APPENDIX 2
PRELIMINARY STUDY FOR EXTENSION LINE
CONNECTING TO 6TH OF OCTOBER CITY

APPENDIX 3
NAT COMMENTS WITH JST RESPONSE
ON DRAFT REPORT 3/4

JST has received NAT comments on draft Report 3/4 in January and early February 2010, and has prepared the response on these comments in cooperation with each department/sector through several technical meetings as shown below.

Figure 2.3 Plan View of Three Alternative Mass Transit Alignments

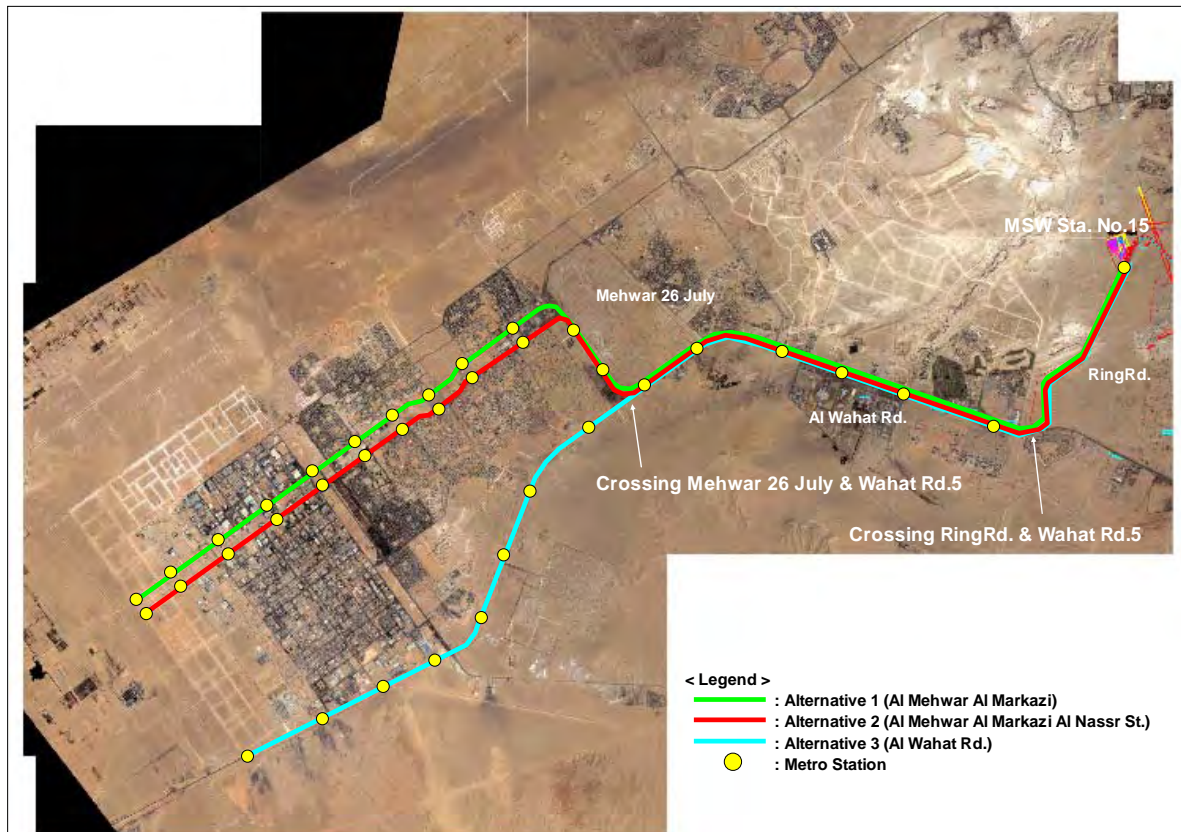
2.2.3 Alignment of 3 alternatives		
14	All your explanation can not be clearly understood because it is not related to a clear map.	JST will update Section 2.2.3 with consideration of relation between Figure 2.3 and text.
Figure 2-4 & 2-5		
15	These two figures should be related to each other (i.e. to be one figure) with a proper scale and presentation.	JST will show figures 2-4 & 2-5 in one figure and incorporate in to the Final Report 3/4 Drawings documents.

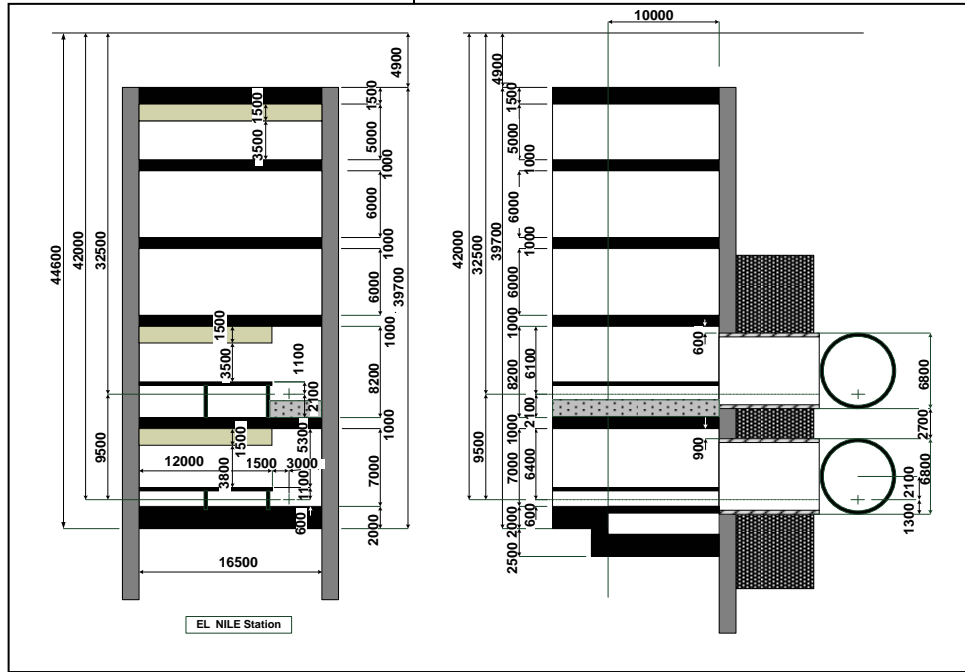
15	Study to minimize the under platform height to be the minimum.	Stations with two platforms in different levels are No.3 (El Nile Station) , No.4 (El Giza Station) and No.13 (GEM) . Upper platform height from the intermediate slab is 3.2m in these stations. This height is necessary for launch or arrival of TBM, because every launch and arrival shaft is planned at both end of each station. Necessary

height for launch and arrival shaft of TBM is shown in following figure.

JST will consider the possibility to minimize the height in the design stage.
